Access Compliance Report

Public Rights-of-Way

(Curb Ramps)

Intersection ID: 46912	Main Street: PARKERS_CROSSING_DR	Cross Street: ANGELA_MARIE_CT	Location: NW
ADA ID: 8E33F319A083	Ramp Type: Perpendicular Diagonal	Initial Pass/Fail: Fail	Overall Compliance: No
Severity Score: 21.25			
Codes/Mitigation Info/Possible Solution		Field Measurements/Component Compliance

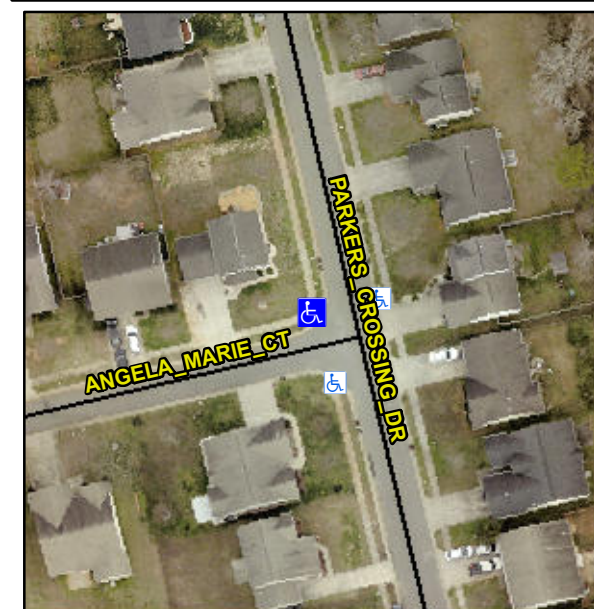
Not Found, R304.5.1, R304.2.2

Compliance	Description	Data	Compliance	Description	Data
N/A	Ramp Length (in)	47.5	No	Ramp Slope (%)	9.0
No	Ramp Width (in)	36.0	Yes	Ramp XSlope (%)	1.2
N/A	Flare Type LT	N/A	N/A	Flare Type RT	N/A
N/A	Flare Slope LT (%)	N/A	N/A	Flare Slope RT (%)	N/A
N/A	Flare Traversable LT?	N/A	N/A	Flare Traversable RT?	N/A
N/A	Landing Length (in)	N/A	N/A	DWS Provided?	N/A
N/A	Landing Width (in)	N/A	N/A	DWS Contrast?	N/A
N/A	Landing Slope (%)	N/A	N/A	DWS Length (in)	N/A
N/A	Landing X Slope (%)	N/A	N/A	DWS Full Width?	N/A
N/A	Landing Curb? (Y/N)	N/A	N/A	DWS Offset (in)	N/A
N/A	Shared Landing?	N/A			
N/A	Gutter Ponding?	N/A	N/A	Gutter Slope (%)	N/A
N/A	Gutter Lip Ht (in)	N/A	N/A	Gutter X Slope (%)	N/A
N/A	Painted X Walk1?	No	N/A	Painted X Walk2?	No
	X Walk 1 Direction	To S		X Walk 2 Direction	To E
N/A	X Walk 1 Width (in)	N/A	N/A	X Walk 2 Width (in)	N/A
	X Walk 1 Slope (%)	2.1		X Walk 2 Slope (%)	1.1
	X Walk 1 X Slope (%)	0.5		X Walk 2 X Slope (%)	2.2

Remove & Replace Curb Ramp With Two New Directional Ramps or Equivalent.
